Technical Service Information

THM 4L80-E NEW CASE, SPACER PLATE AND GASKET

92-43

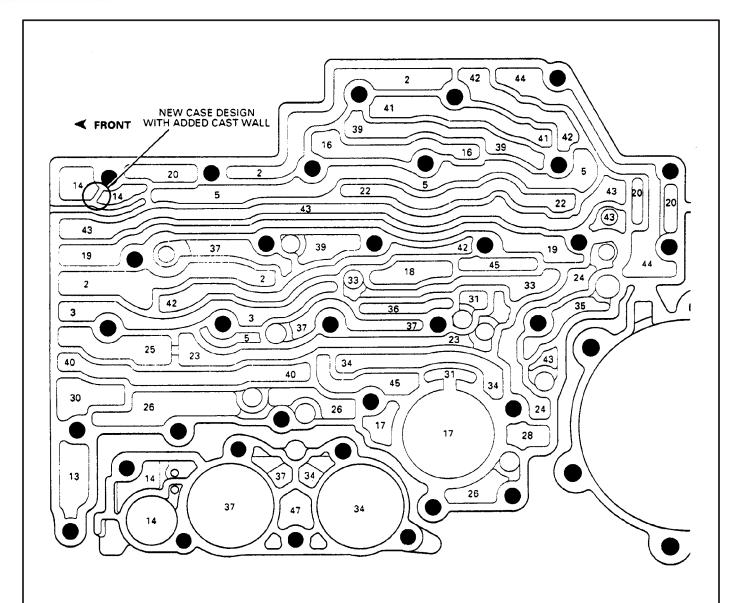
Beginning August 21, 1991 (Julian Date 233) all THM 4L80-E/4L80-EHD transmissions were-built using a new case assembly, new valve body spacer plate, and new spacer plate gaskets.

To correct high line pressure instabilityand improve durability.

- (1) TRANSMISSION CASE Oil dam was added to the worm track area in the torque signal oil circuit, as shown in Figure 1.
- (2) SPACER PLATE Slot removed and an orifice added to the torque signal oil circuit, to correct the line pressure instability.
- (3) SPACER PLATE GASKETS Hole configuration changed to accommodate the added orifice in the spacer plate.

The new case assembly, new spacer plates and gaskets, MUST be used together to correct the line pressure instability concerns. The new spacer plates and gaskets can be used with the previous case (No Dam) and will function, but WILL NOT CORRECT line pressure instability. To correct line pressure instability concerns on units built prior to Julian Date 233, refer to ATSG Bulletin 92-34.
